Access Compliance Report

Public Rights-of-Way

Intersection ID: 11841	Main Street: E_18TH_ST	Cross Street: HARRILL_ST	Location:	N
ADA ID: DDBE35EFFE2D	Ramp Type: Directional1	Initial Pass/Fail: Pass	Overall Compliance: No	Severity Score: 0

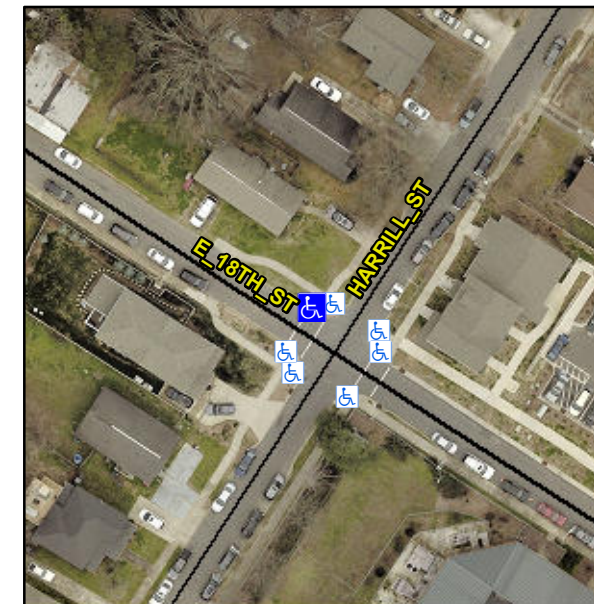
RP SL < 5%

Not Found, R304.5.3, R302.7

Possible Solutions:

Remove & Replace Entire Ramp.
